MID BLOCK

8820 Aurora Ave N
Seattle, WA

Recommendation Meeting
August 15, 2016
DPD # 3020795

Early Design Guidance Response

Level 1 | Warehouse and Entry

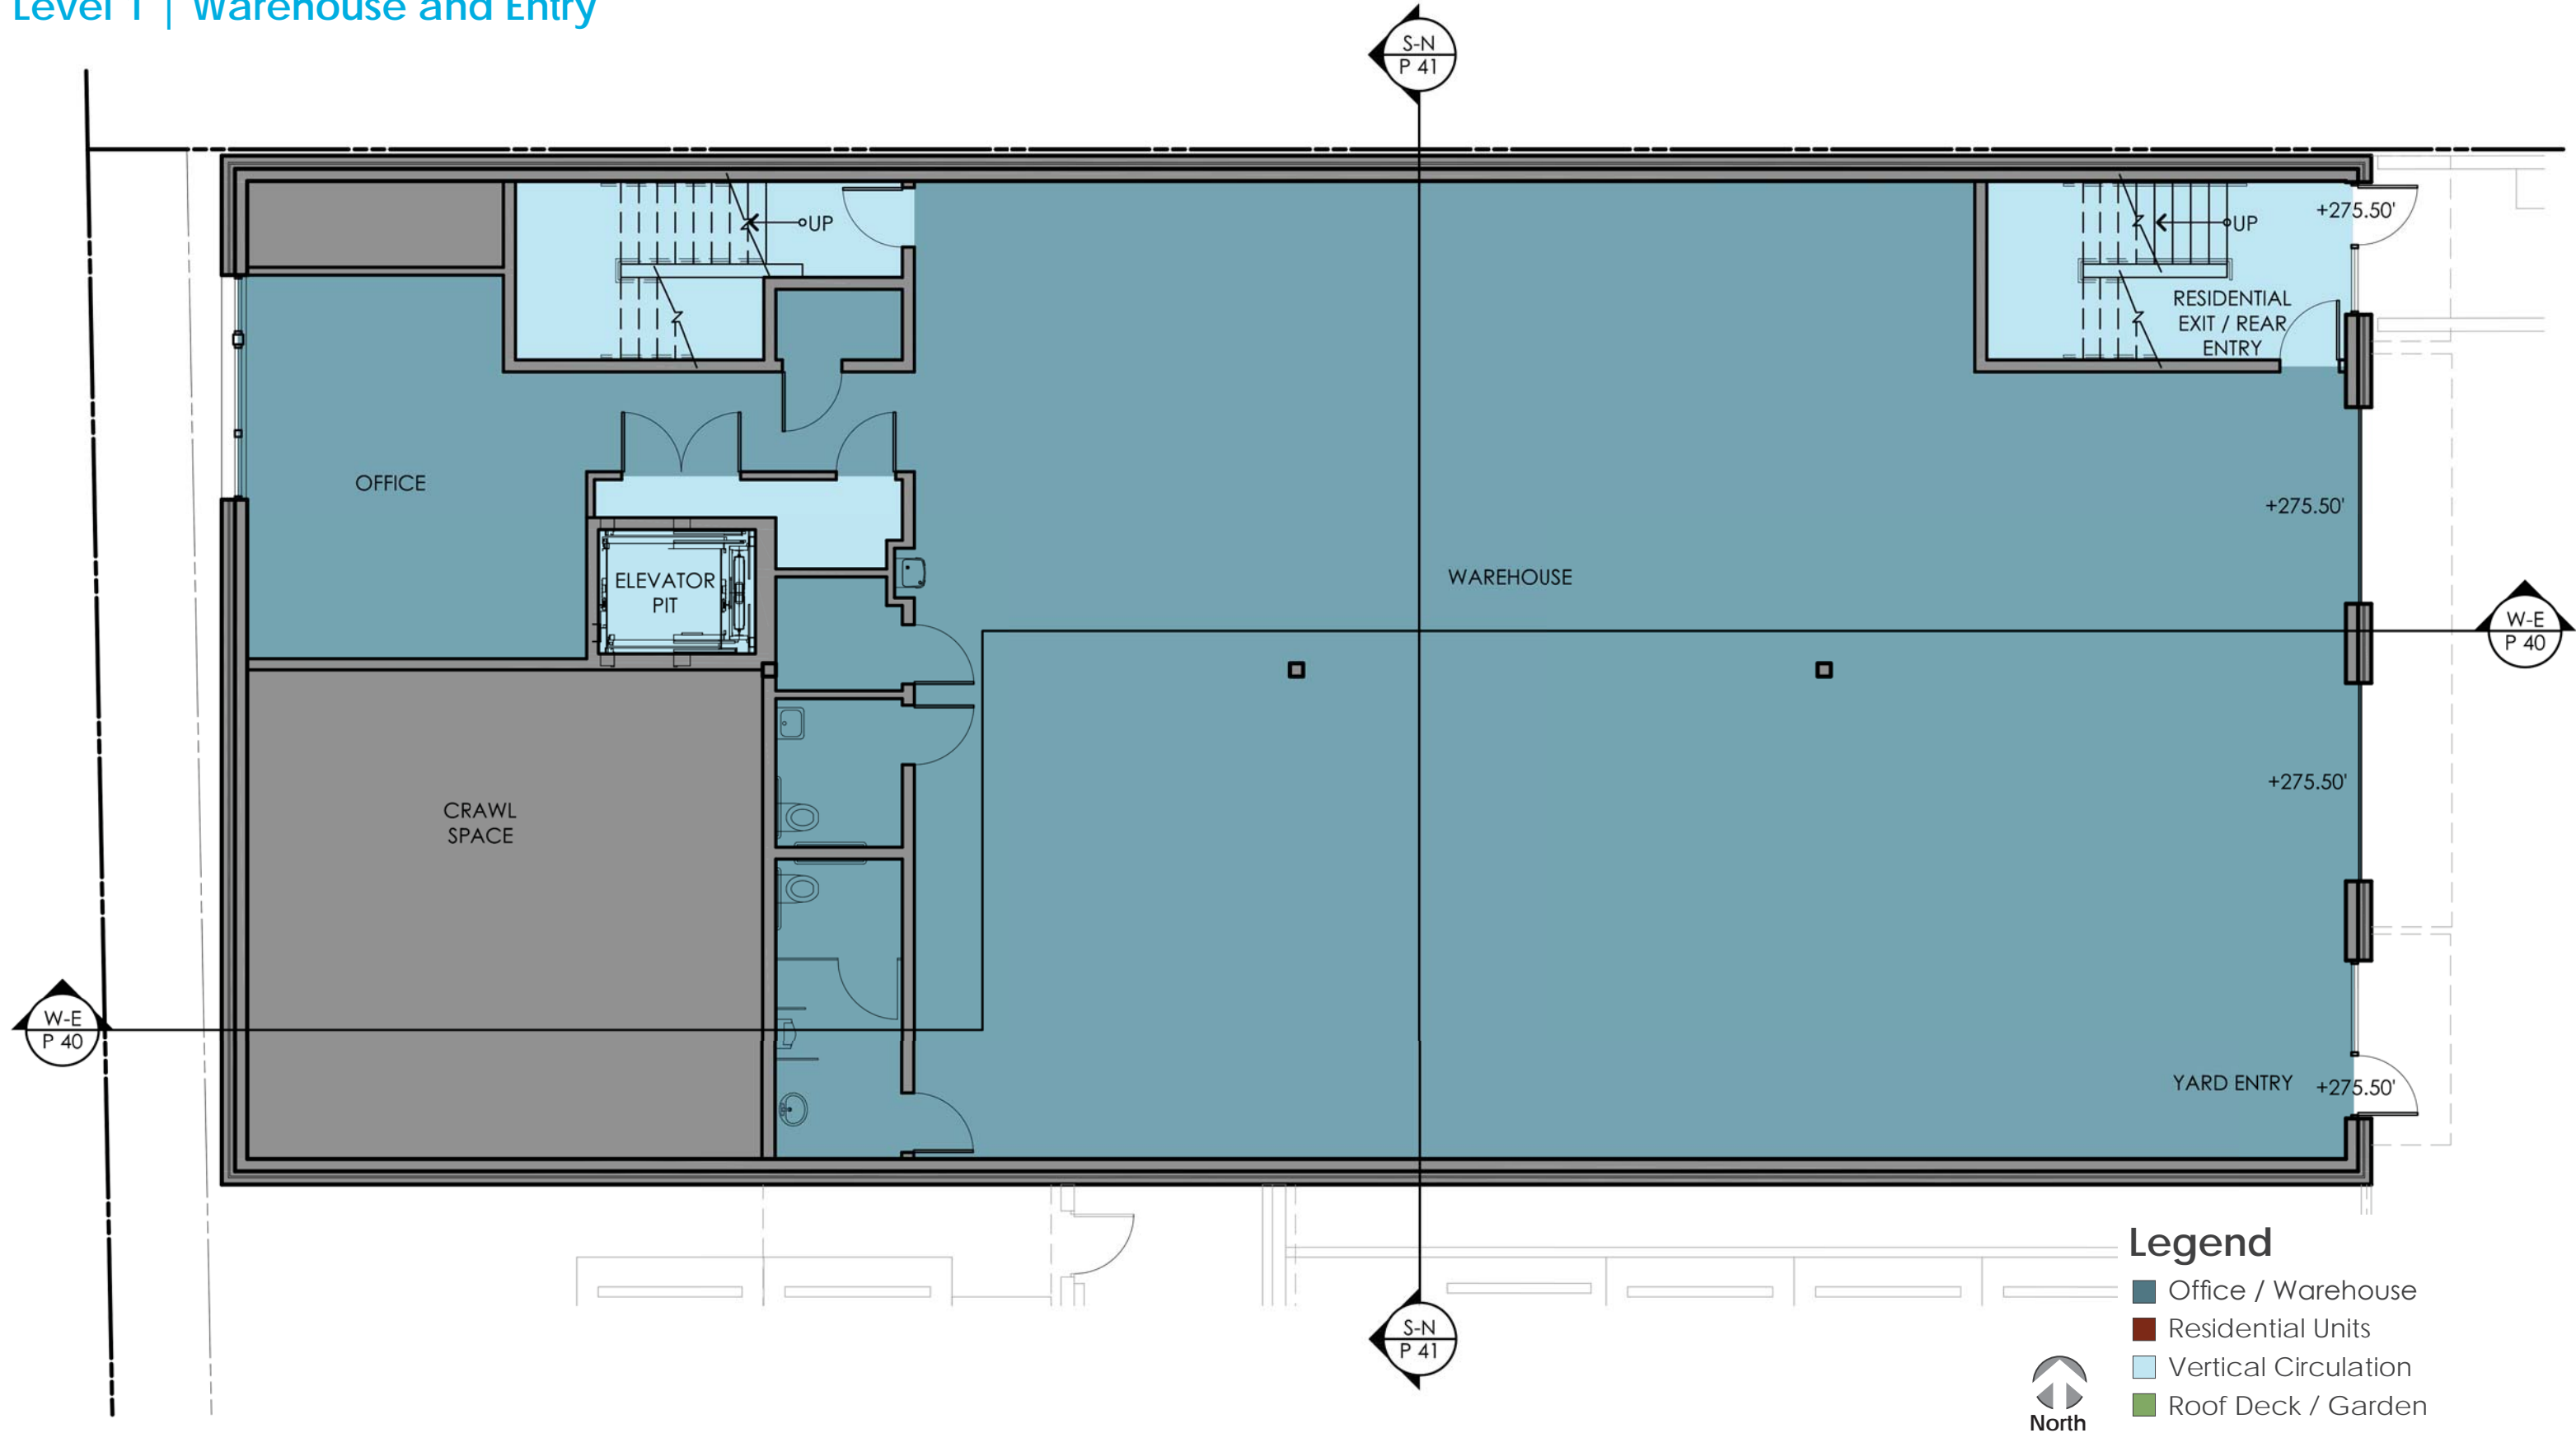
- a. The Board voiced concerns about safety in the proposed storage yard area and the remote location of the external waste collection area. The Board stated that it is imperative that the storage yard area be appropriately secured and that the waste storage area is located within closer proximity to its residential users. The Board

expects these concerns to be resolved in the next design iteration. (PL2.B, DC1.C)

Response: Storage yard is secured with a 8' high metal wire fence and a 10' high CMU walls, with a matching vehicular gate. Security cameras and lighting will also be utilized. The building pedestrian access off of Nesbit is gated (key or card key access) and secured with a 7'-4" high ground face CMU wall. Lighting will be utilized at the pedestrian level.

Trash enclosure has been relocated for better access for residential tenants, which will allow them to access the trash via the elevator and an accessible route from the building to the trash enclosure. The commercial trash enclosure is located near Nesbit and screened from the street and the residential entry.
